**RE: Iron Duplex - Resubmittal
Grading and Drainage Plan
Stamp Date: 5/2/17
Hydrology File: K13D074**

**RE: Iron Duplex - Resubmittal
Grading and Drainage Plan
Original Stamp Date: 11/22/16
Revision Stamp Date: 4/4/17
Hydrology File: K13D074**

Based upon the information provided in your submittal received 4/5/2017, the Grading and Drainage Plan resubmittal **is not** approved for Building Permit. The following comments need to be addressed for approval of the above referenced project:

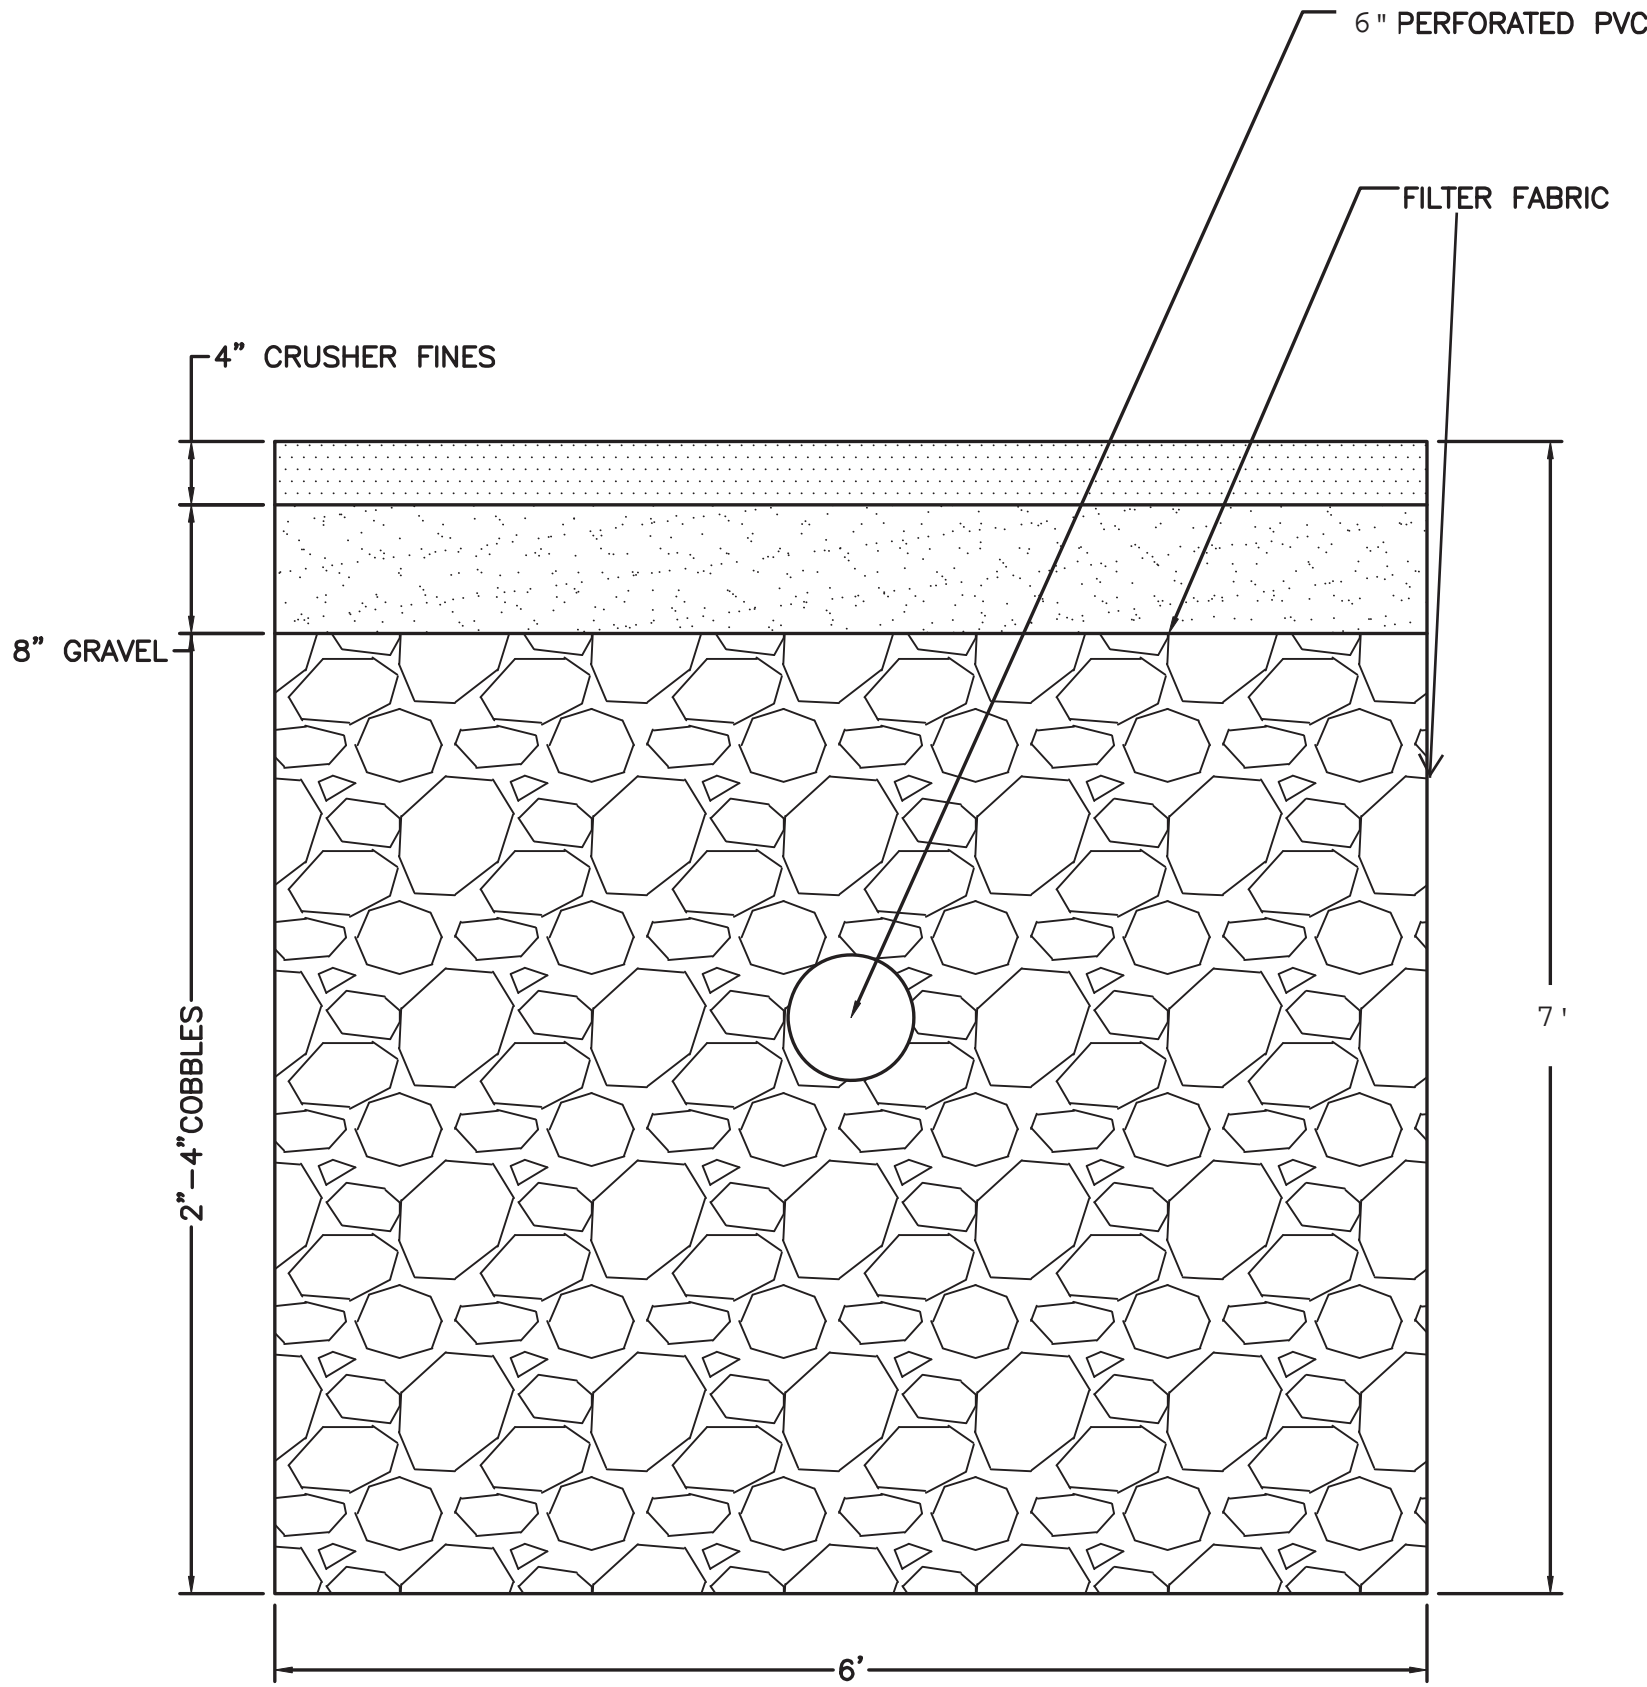
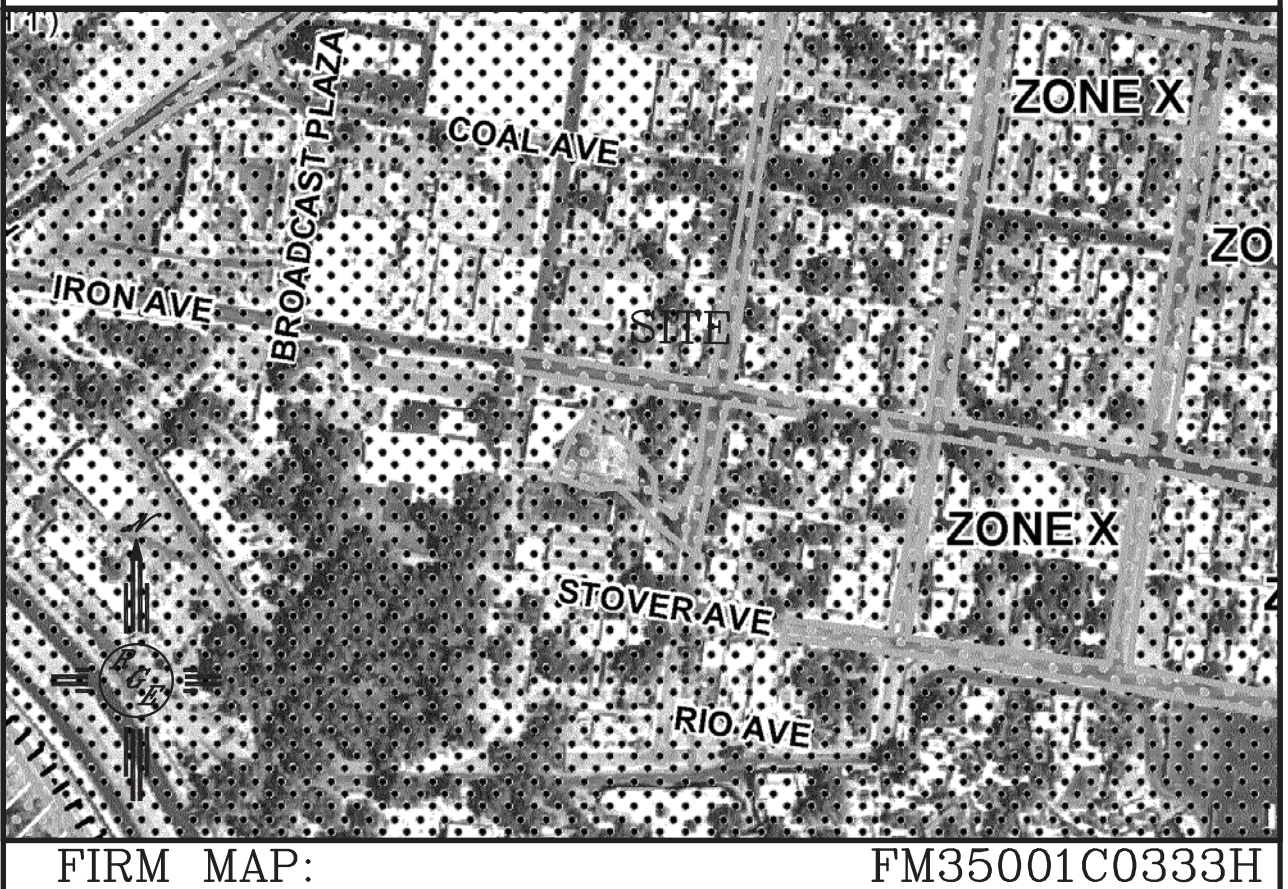
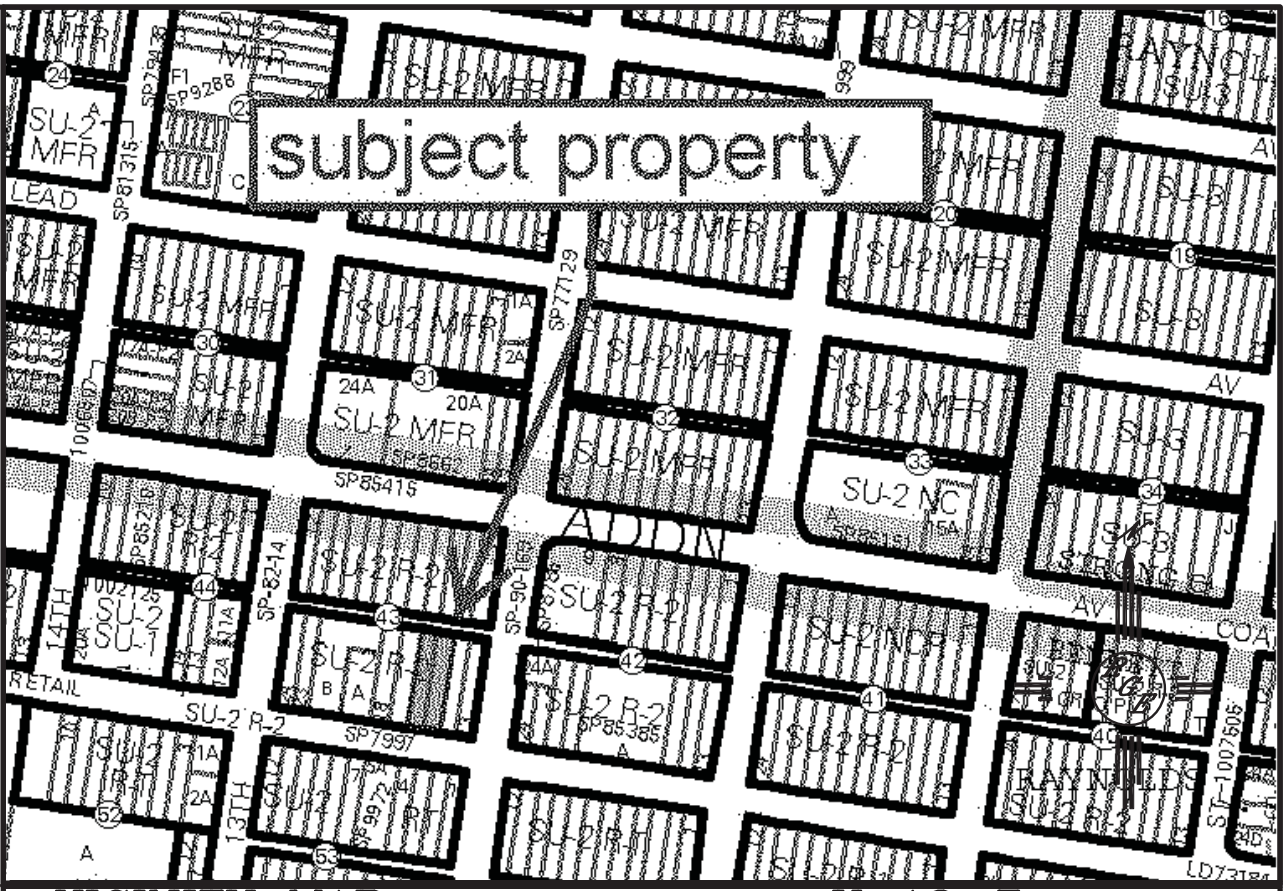
1. As a constructability issue, it is hard to tell what you are installing and what you are not. Please place a big "X" over the old ponds and driveway. Then place a new viewport showing what you are proposing to install. It will make it a lot easier for both the contractor and the building inspector to immediately see what is to be built. **WE HAVE REDRAWN PLAN TO CLARIFY**
2. It appears that the 6'x7'x48' trench is drawn 47'. Please check the length of the trench. **WE HAVE RE DRAWN THE PROPER WIDTH**
3. Please provide a detail for the trench. Again this will help both the contractor and the building inspector know what is to be built. **WE HAVE ADDED A TRENCH CROSS SECTION**
4. The proposed trench is to provide 520 CF of retention. The required retention is 530 CF. It appears that your new system is about 10 CF short.

**WE HAVE ADDED SMALL PONDS IN THE FRONT THE
PIPE HAS A CAPACITY OF 12 CF**
